# ***Bowral & District Hospital Redevelopment***

*State Significant  
Development  
Modification  
Assessment  
(SSD 8980 MOD 1)*

November 2019

**Figure 3 | Proposed Level 2 Plan (SSD 8980 MOD 1)**

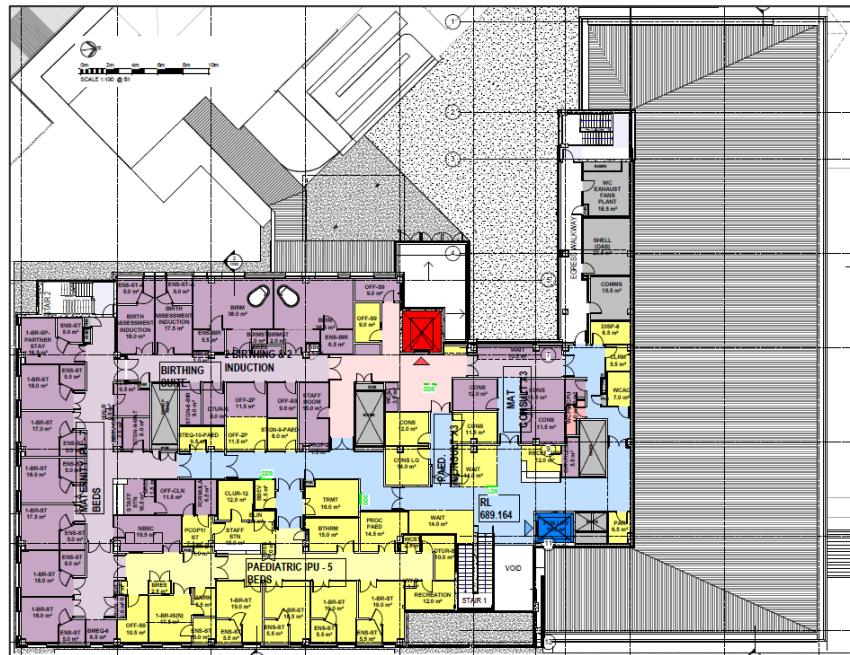
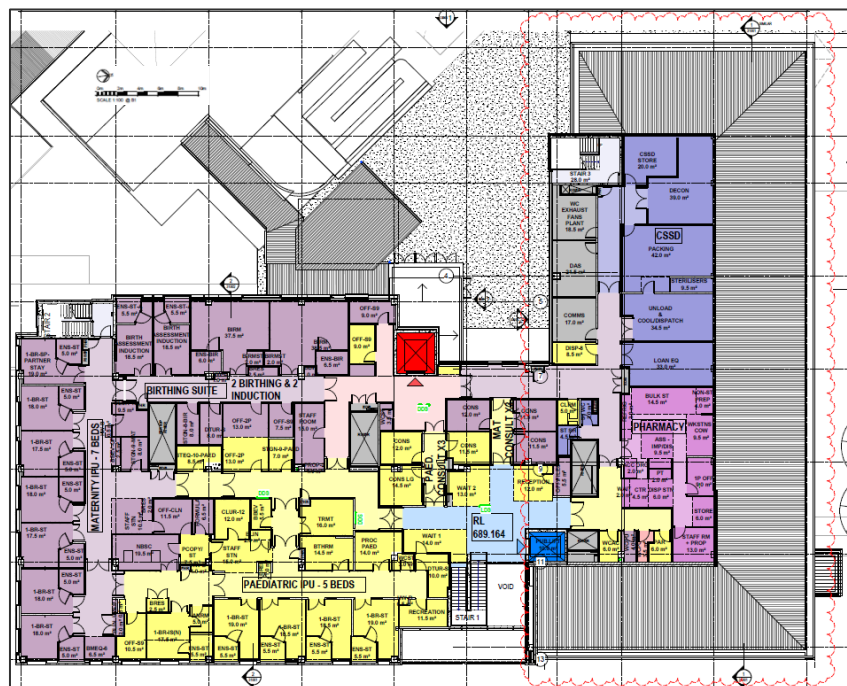
The proposal seeks approval to reconfigure the internal layout of Level 2 and Level 3. These changes include the relocation of the Central Sterilising Department, pharmacy, bathrooms and plant rooms. The reconfiguration is a result of design development and alignment of the Hospital's configuration with NSW Health Infrastructure operational requirements.

The proposed floor space increase will add 493sqm to the development, which represents a 6 per cent increase from the approved total floor space of 8,159sqm. The additional floorspace does not result in a breach of the approved height of 20.3 metres. The Department notes that the site is not subject to a maximum floor space ratio under the Wingecarribee LEP 2010.

The Department considers that the proposed changes are acceptable as they would improve the functionality of the hospital and medical services as the changes would not reduce patient and staff numbers. The Department also considers that the increase in floor space to be minor. Therefore, the Department considers the proposed modifications would have negligible impacts and recommends that the proposed modifications be approved.

**Figure 5 | Proposed Level 3 Plan (SSD 8980 MOD 1)**

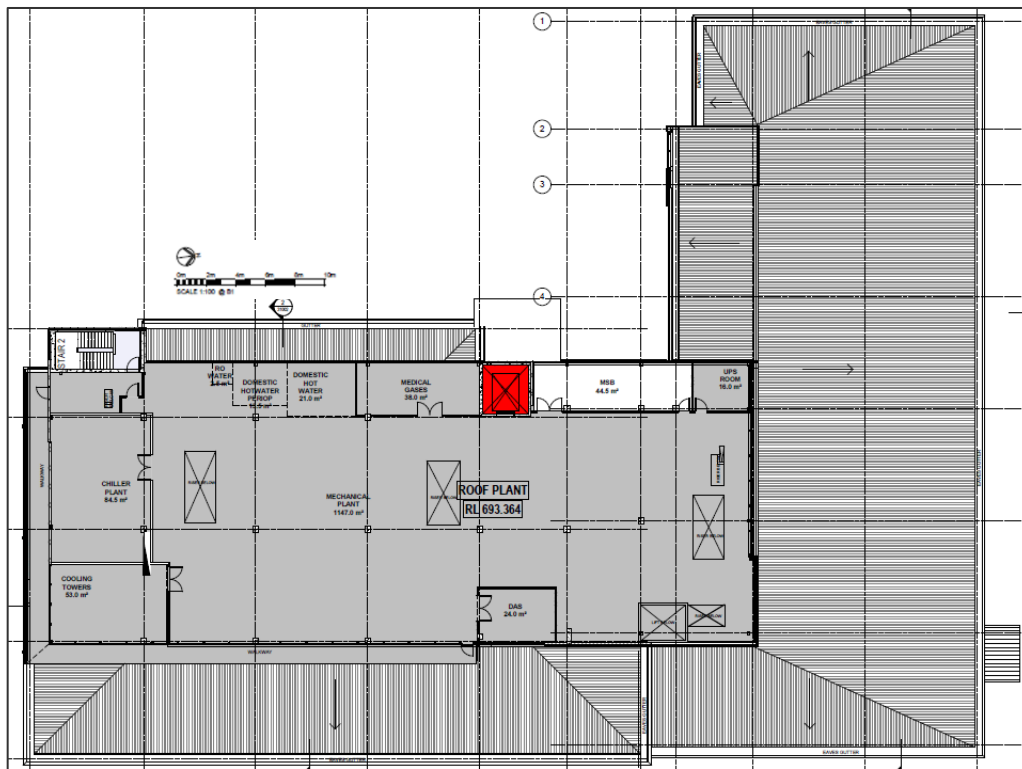
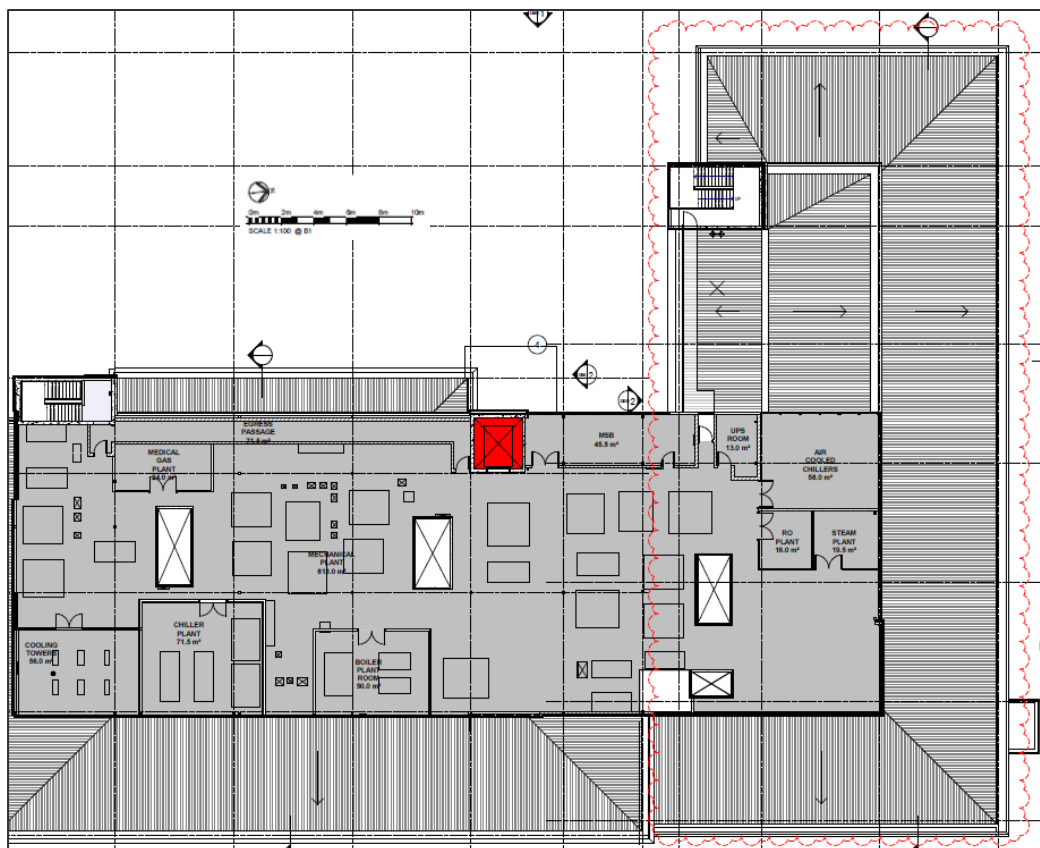
The modification request seek approval for minor changes to the external materials and finishes, roof pitch and building elevations. The Applicant is also seeking approval to add a suspended walkway from Level 3 over the roof, roof flues and cowls to the roof level, and an additional level of fire stair egress from the proposed Level 3.

The Applicant has identified that with the addition of floor space on Level 3, a suspended walkway from Level 3 to the fire egress stairs is required to enable safe exit from the building. The proposed walkway extends from the western edge of Level 3 to the approved fire stair egress. The walkway will only be visible from within the site of the hospital and will not significantly increase the built form of the development.

The Department is satisfied that the proposed modifications are acceptable as the modifications are minor in nature and are in keeping with the approved design scheme. The Department, therefore, concludes that the proposed external design modifications are acceptable and would not result in any adverse visual, aesthetic or amenity impacts.

**Figure 6 | Proposed Roof Level Plan (SSD 8980 MOD 1)**

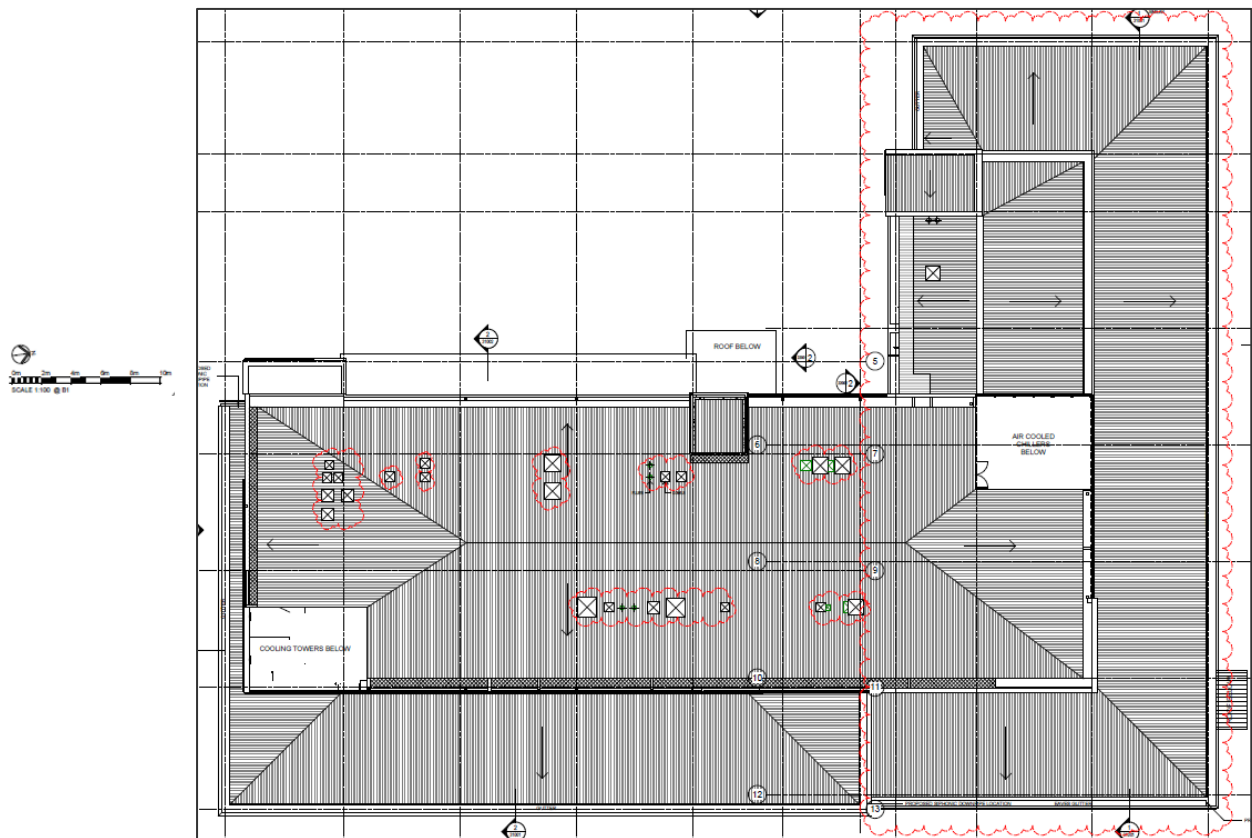
The proposed roof flues and cowls (as seen in **Figure 6** and **8**) have been added to reflect the modified layout of the plant rooms on Level 3. The Department notes that the flues are excluded from the total building height and that they have been located away from street frontages where possible.

**Figure 8 | Proposed East Elevation (SSD 8980 MOD 1)**

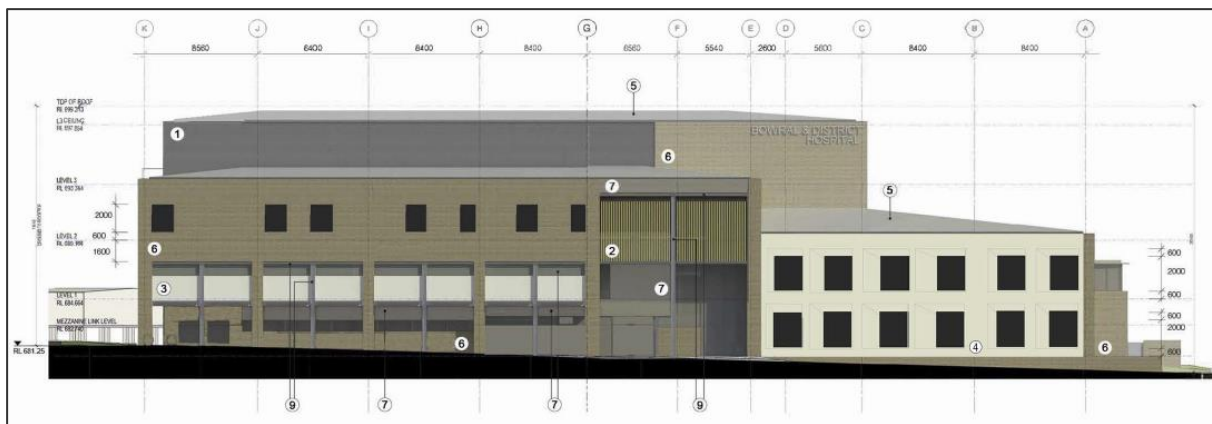
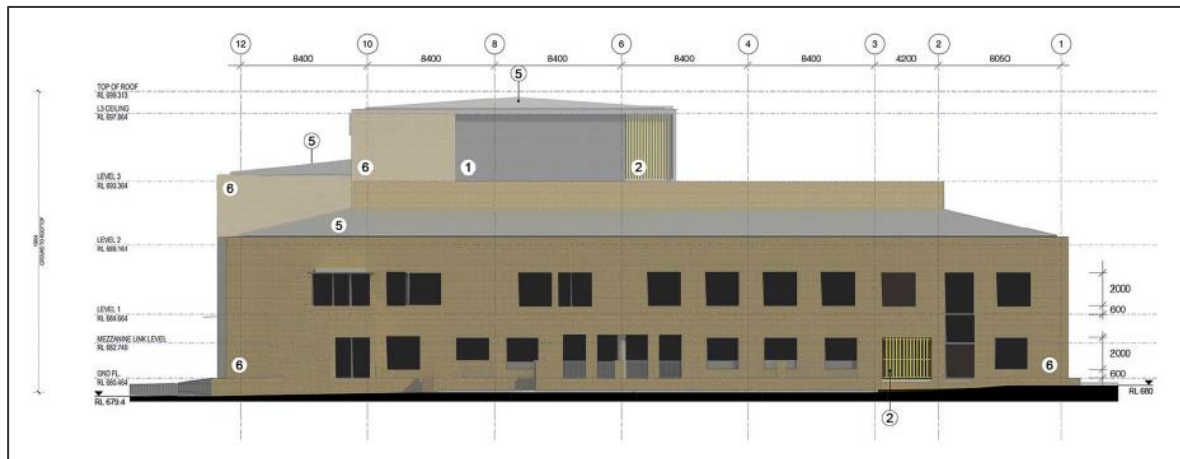
To accommodate the additional floor space, the modification application proposes to extend Levels 2 and 3 towards Bowral Street. As seen in **Figure 7** and **8**, the proposed extension of floorspace maintains a setback from the northern edge of the Hospital.

The Department is satisfied that the additional massing of the proposed modification has minimal visual impact, as the additional floor space maintains a setback from Bowral Street. The Department also notes that the additional floor space will enable the Hospital to operate effectively. As such, the Department considers the proposed massing to be suitable.
